## Addendum No. 1

**Project:** Salem Community Schools  
2021 FEMA Safe Room Additions

**Date:** April 9, 2021

**Project No.:** 202020.01/02

**P502A**

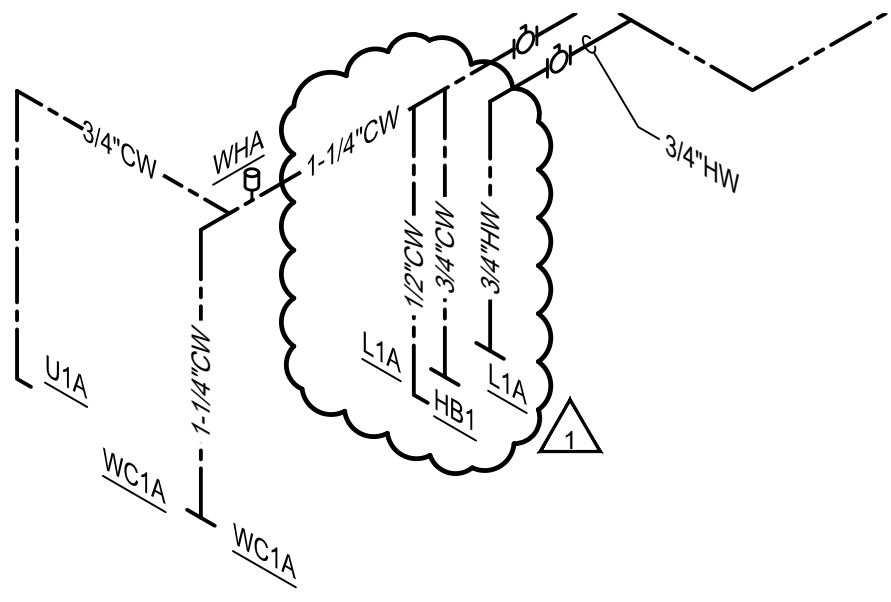
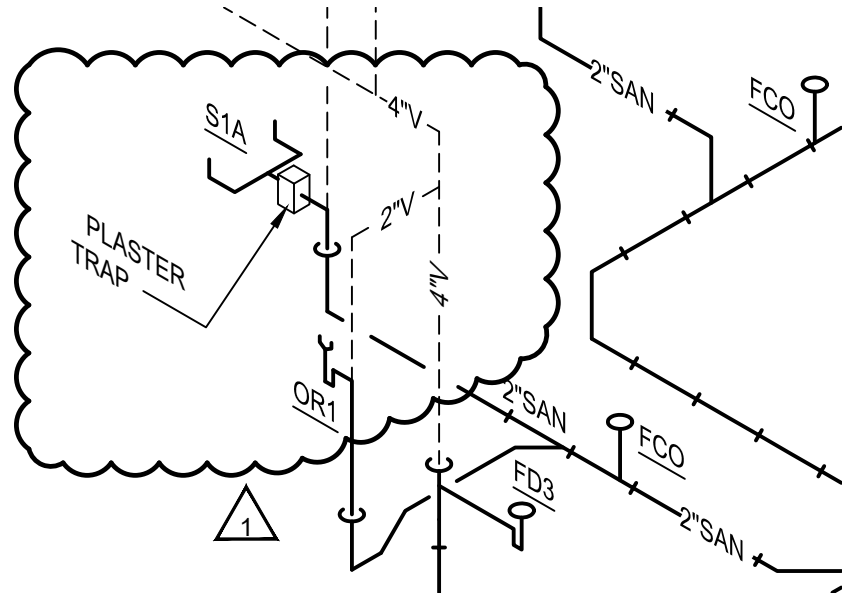
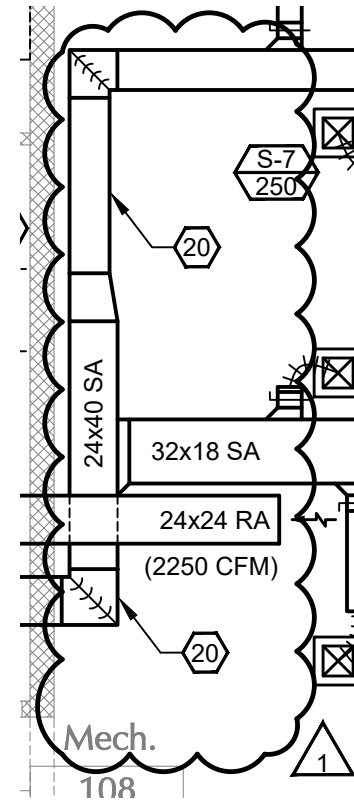
- b. Item 11: Refer to attached revision sketch P502A (applicable to Volume 2 only)
  - A. Add one (1) HB1 fixture in ADA Restroom 4 B108 as indicated on this sketch. Provide with a 1/2" cold water line. Install at 18" AFF adjacent to L1A fixture.
  - B. Install plaster trap for S1A sink in Prep Area B103.

Item 29: Refer to Volume 1 Sheet E201.

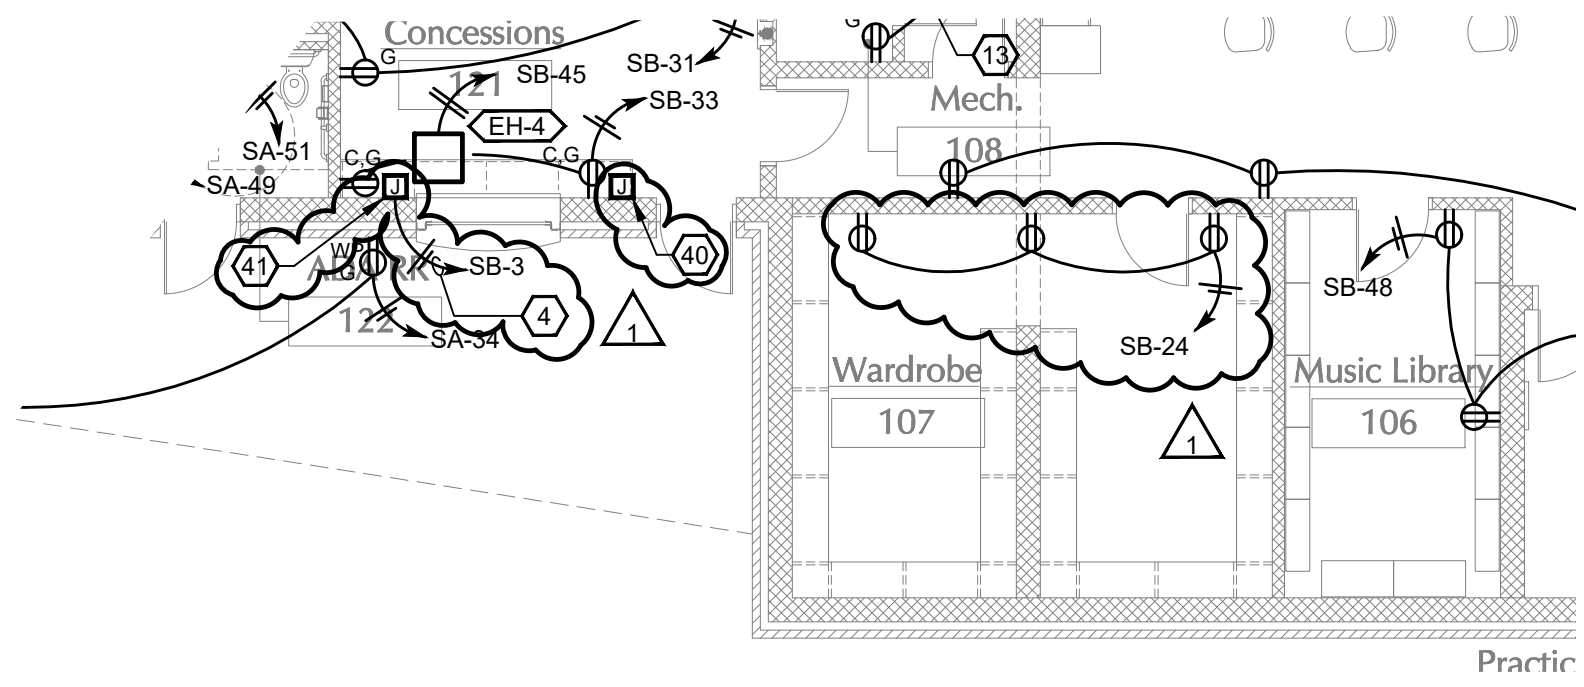
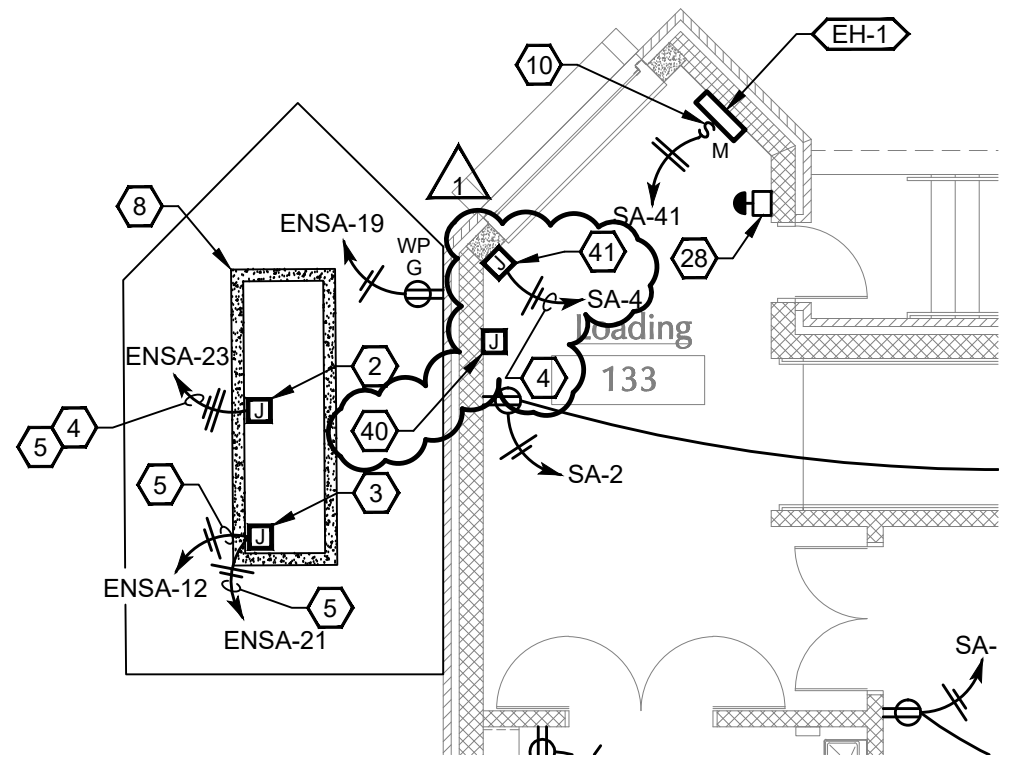
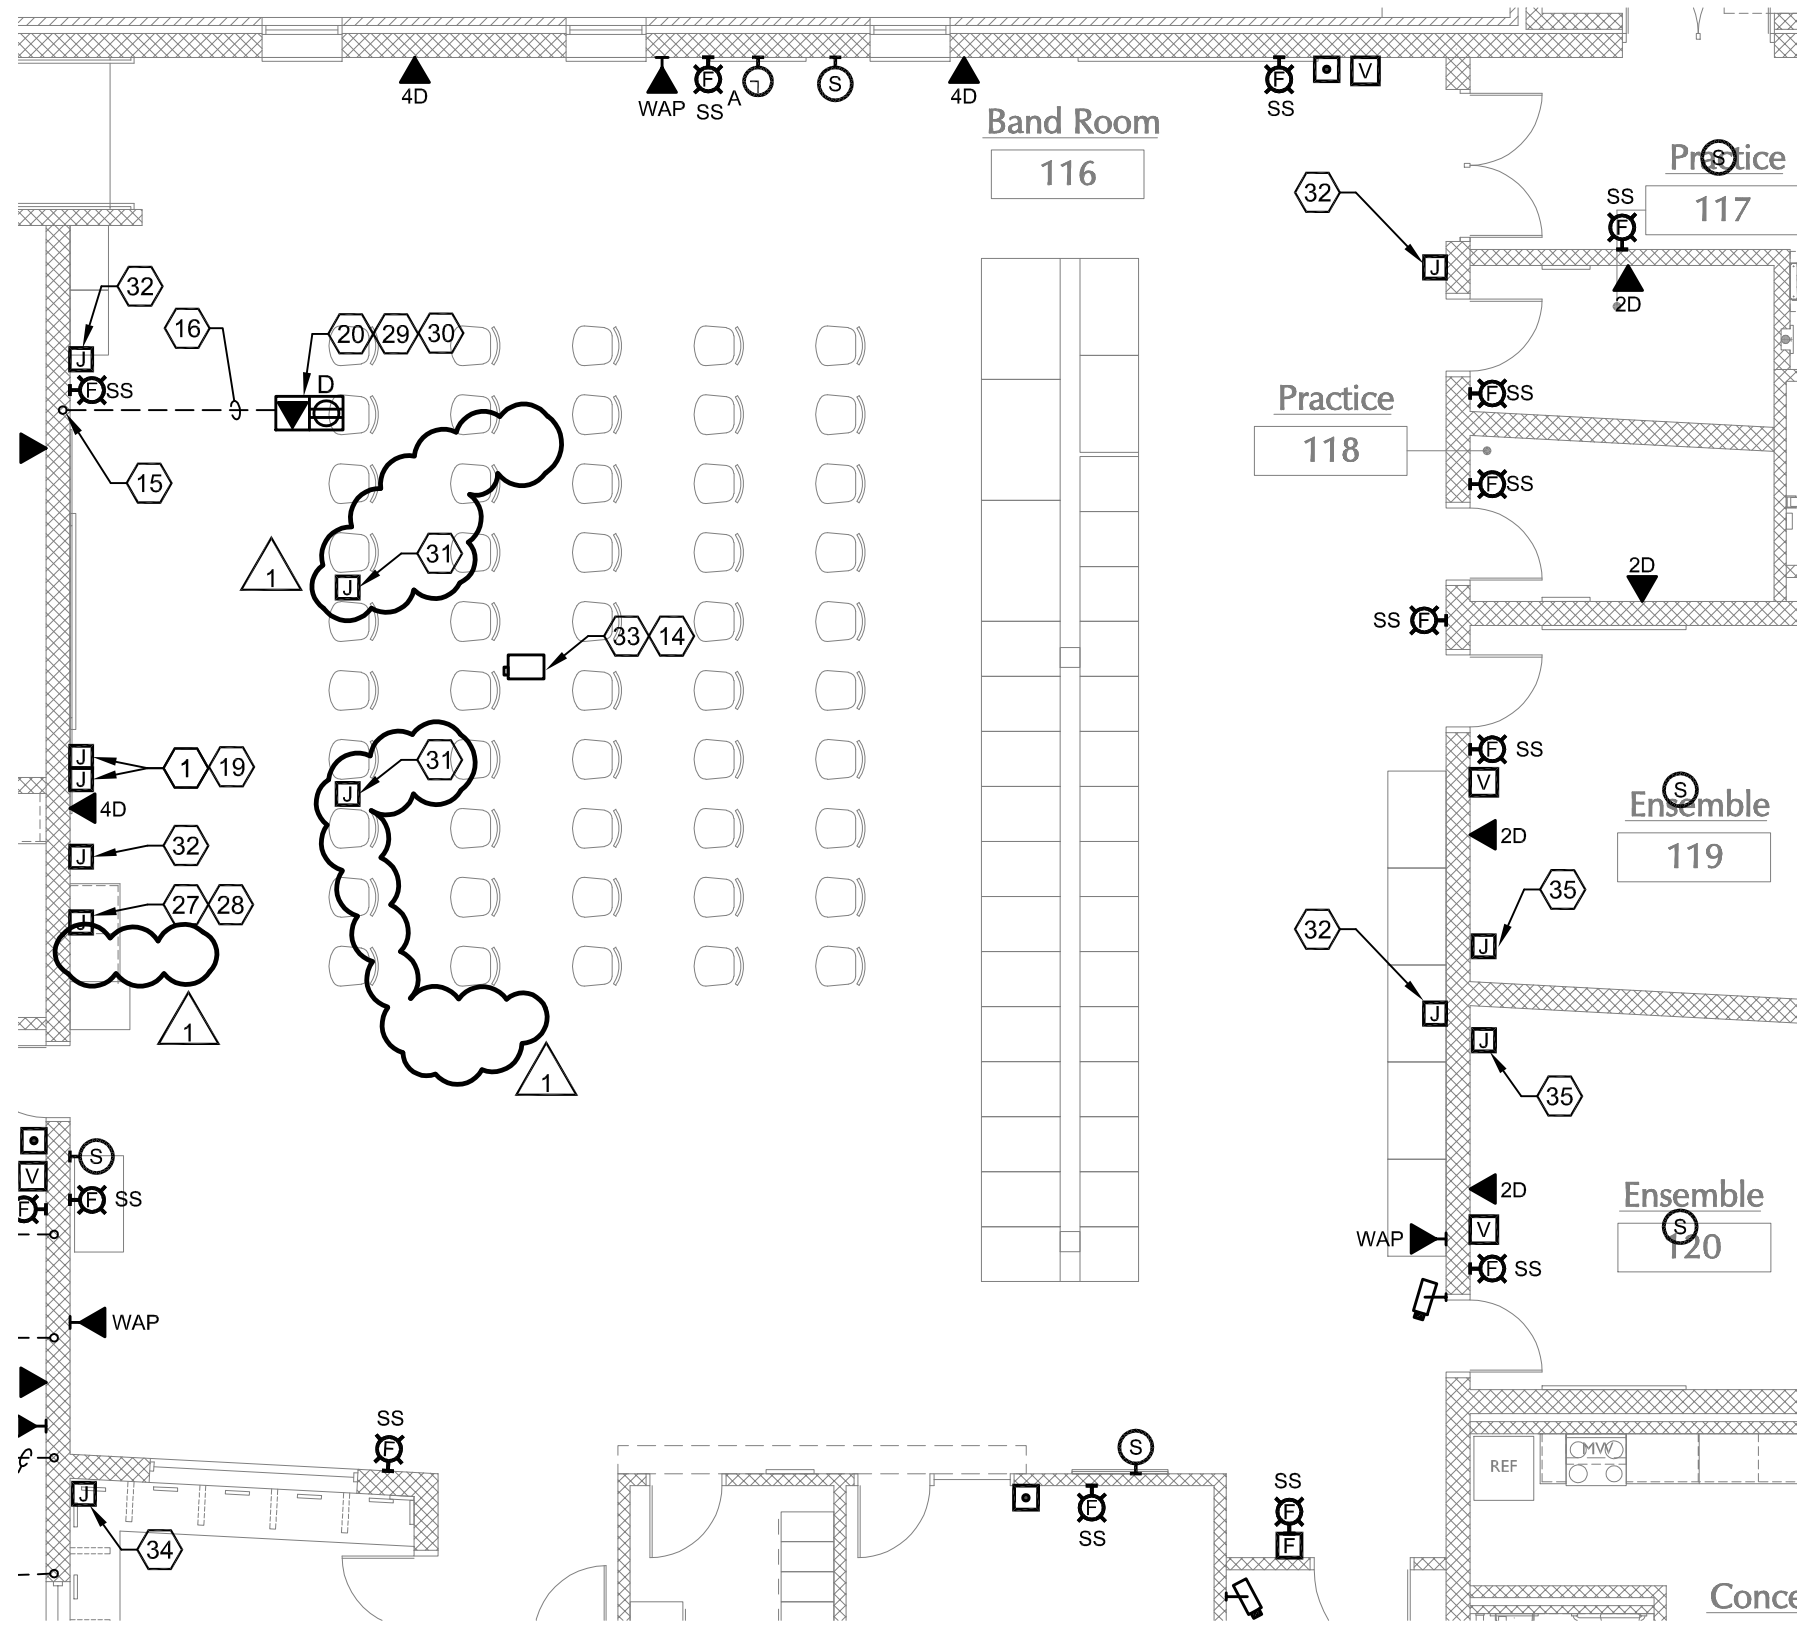
- G. Refer to Loading 133.
  - a. Refer to attached sketch E201A.
    - i. Provide power and field wiring for new motorized coiling door.
    - ii. Provide #10 conductors and #10 ground in 3/4" conduit from 25A/1P breaker in Panel SA circuit #4 for power connection.
    - iii. Provide rough-in and associated controls, devices, etc. for motorized coiling door controls.
    - iv. Coordinate the final locations and all requirements with the manufacturer and architect.
- H. Refer to Volume 1 Concessions 121.
  - a. Refer to attached sketch E201A.

- i. Provide power and field wiring for new motorized coiling door.
      - ii. Provide #10 conductors and #10 ground in 3/4" conduit from 25A/1P breaker in Panel SB circuit #3 for power connection.

- iii. Provide rough-in and associated controls, devices, etc. for motorized coiling door controls.
      - iv. Coordinate the final locations and all requirements with the manufacturer and architect.

SCS  
Sheet  
E301B

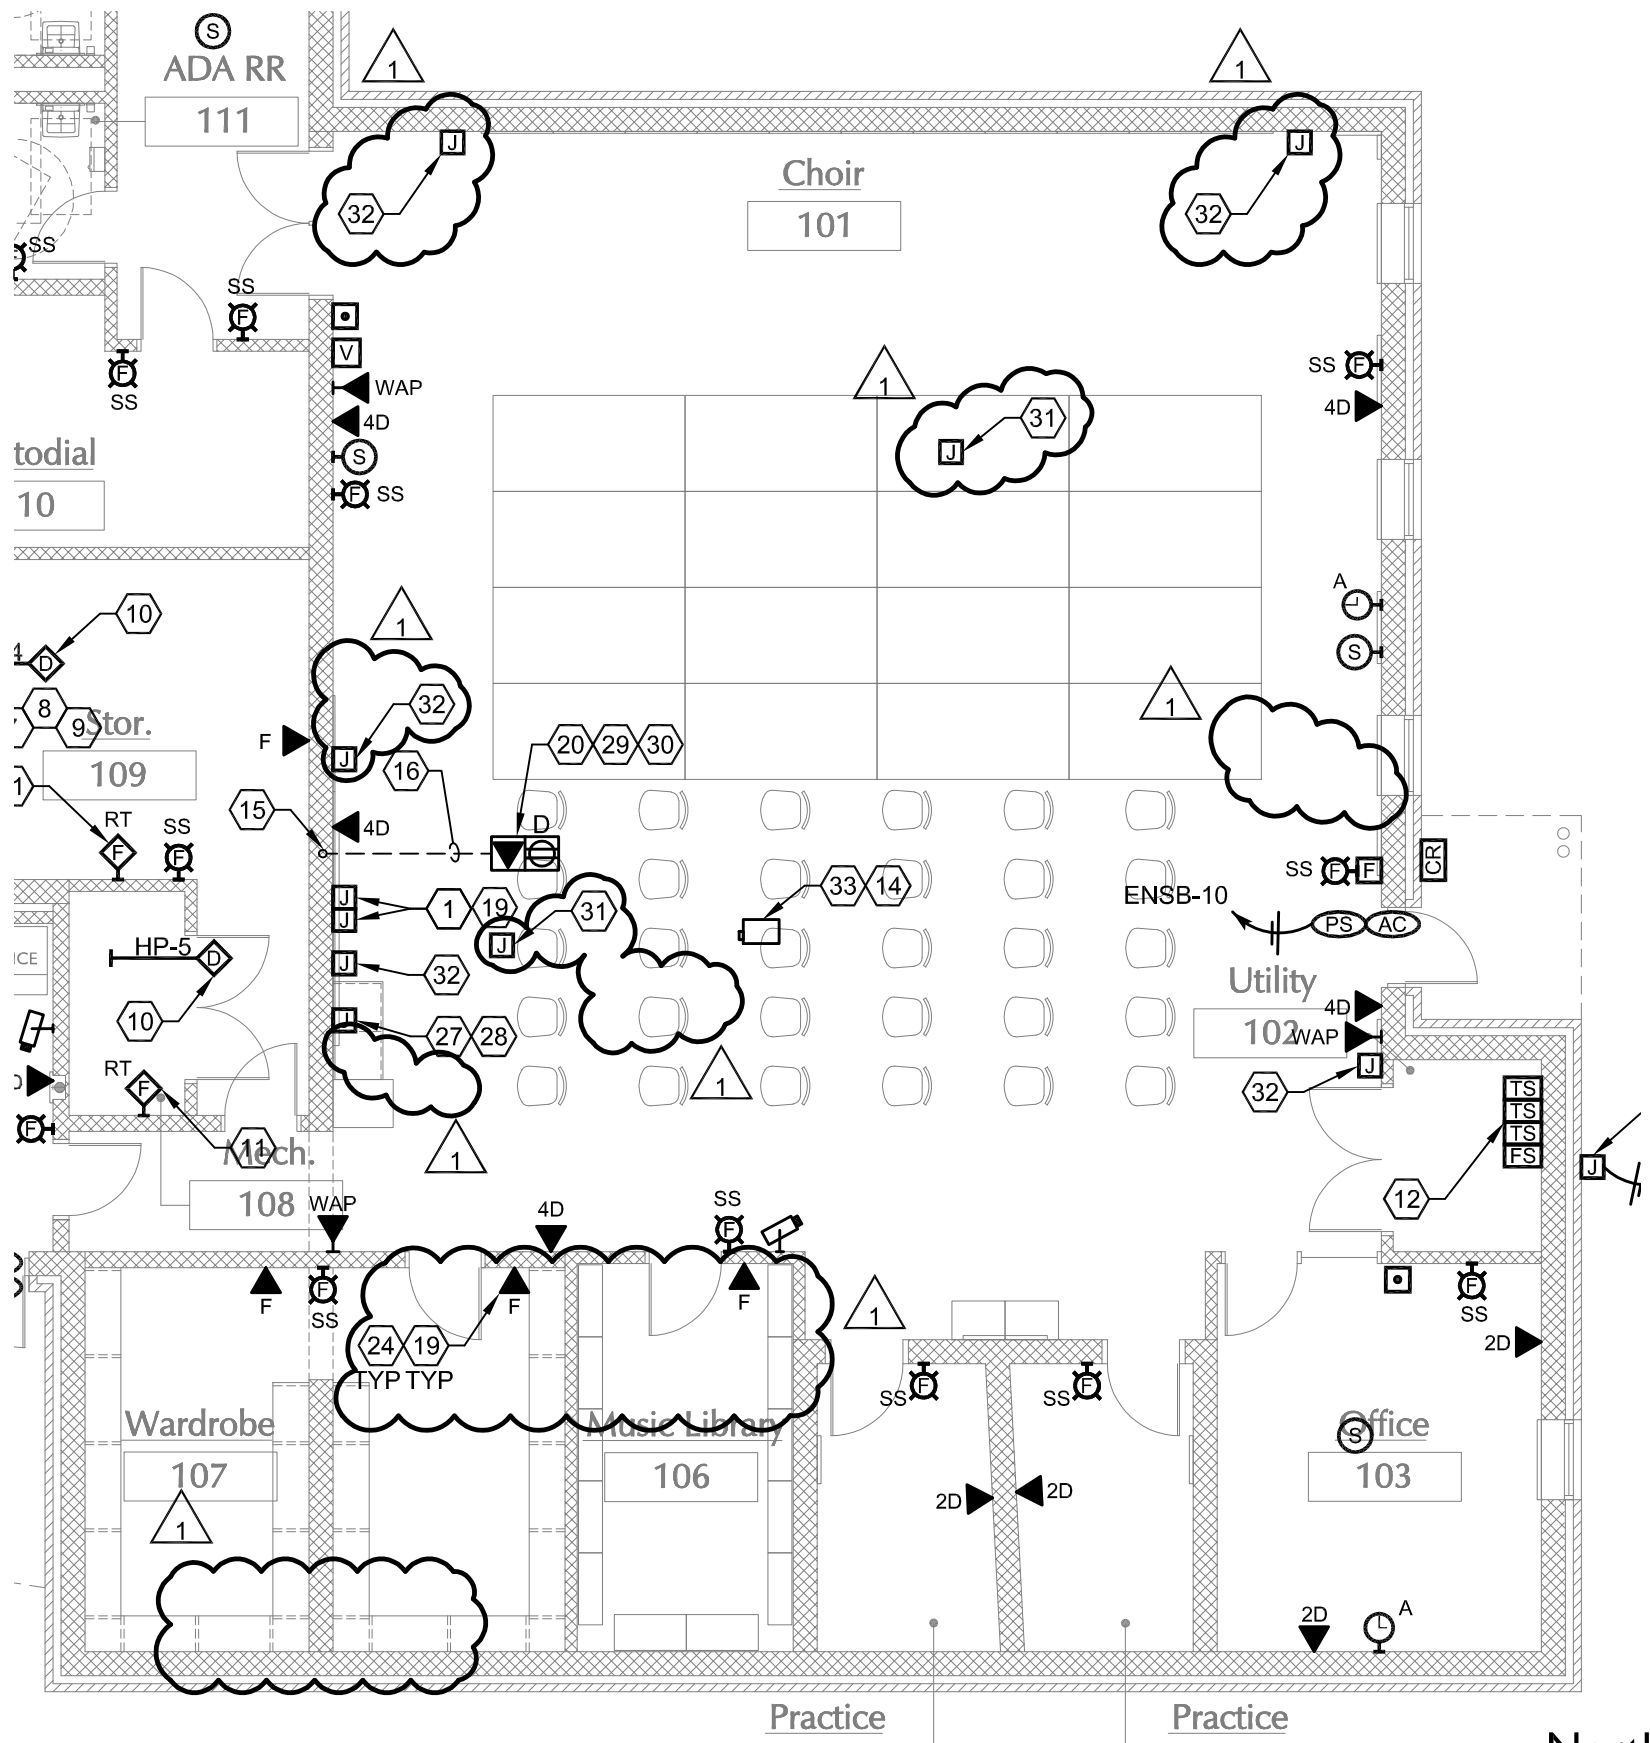
- A. Refer to Choir 101.
  - a. Refer to Band Room 116 and Choir 101
    - i. Refer to attached sketches E301A and E301B for updated A/V equipment layouts and requirements.
    - ii. In addition to the conduits for audio and video connections, provide a 3/4" conduit for power to Type "D" Floor Boxes.
  - b. Refer to Keyboard Lab 128:
    - i. Contractor shall refer to Technology Equipment Schedule T100 and T200 for conduits and added details for Type "B" Floor Boxes.
    - ii. Provide Two 1-1/2" Conduits and Two 3/4" to Type "B" Floor Boxes.

- iii. Provide One 1-1/4" Conduits and Two 3/4 to Type "A" Floor Boxes.
- iv. Provide One 1-1/4" Conduits and Two 3/4 to Type "C" Floor Box.
- B. Refer to Wardrobe 107.
  - a. Refer to revised sketch E301B.
    - i. Future Data rough-in shall be located on north wall in lieu of east wall to avoid painted wood casework. Install adjacent to revised receptacle locations (Quantity 1).
    - ii. Omit two future data rough-ins on south wall.
- C. Refer to mechanical room 130. Provide wall mounted intercom speaker on east wall.
- D. Refer to concessions 121. Clarification: Install 2D data outlet above countertop on west wall (along south wall).
